## Service Bulletin No. 59

TO: Parts & Service Managers  
DATE: May 27, 1994  
RE: Servo Motor Stripping Gears on:

# TOMMY

Fig. 01

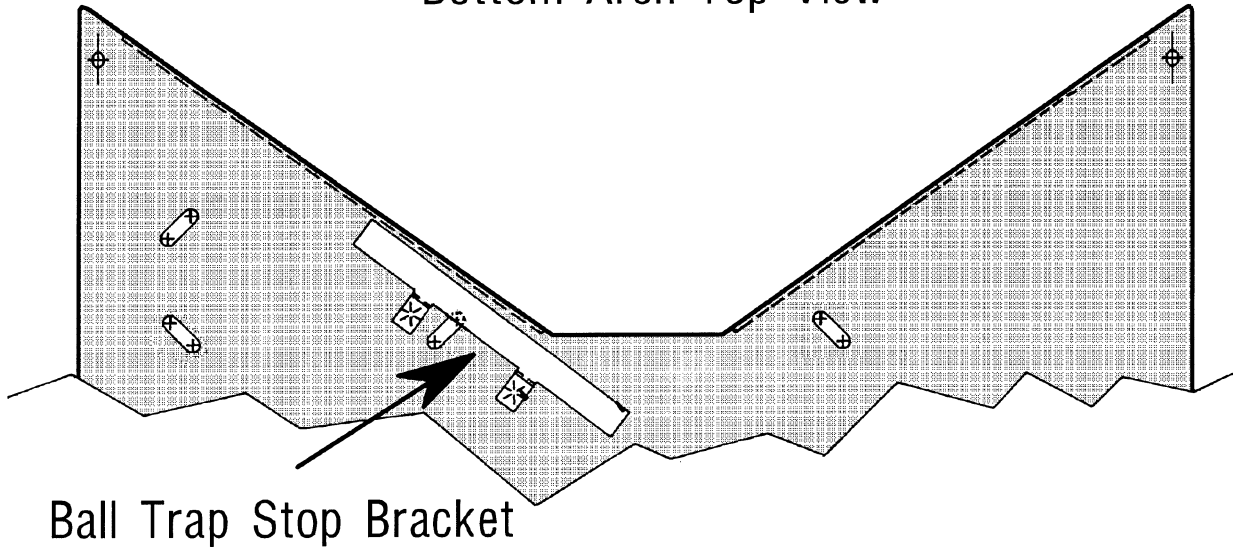
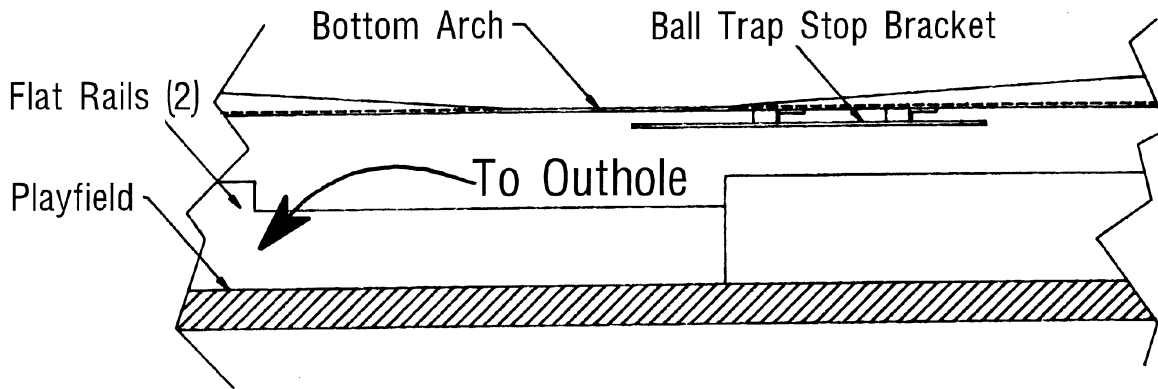
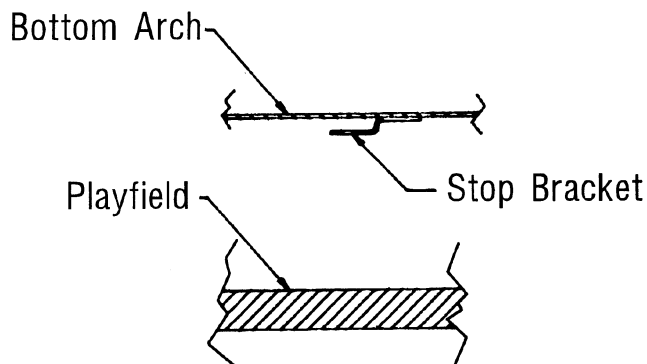
**PROBLEM** The Link Arm and/or the left blinder (top) blade is getting stuck on the underside of the playfield arch. There is a metal strip (bracket) spot welded to the under side of the arch, which protrudes down to prevent ball traps (See Fig. 01). This metal strip (bracket) is getting bent, when the playfield is being lifted by the arch, and in some cases the metal strip (bracket) gets bent downward. In either case this could cause premature failure to the servo motor, if binding occurs.

Inspect the underside of arch to ensure ball trap bracket is not bent. If bracket is bent adjust by re-bending the metal strip (bracket) according to the attached diagrams specifications. The specs. may vary depending on the particular arch assembly being used. The metal strip (bracket) should be parallel to the playfield with no bends.

Note: The Stop Bracket is parallel to playfield.
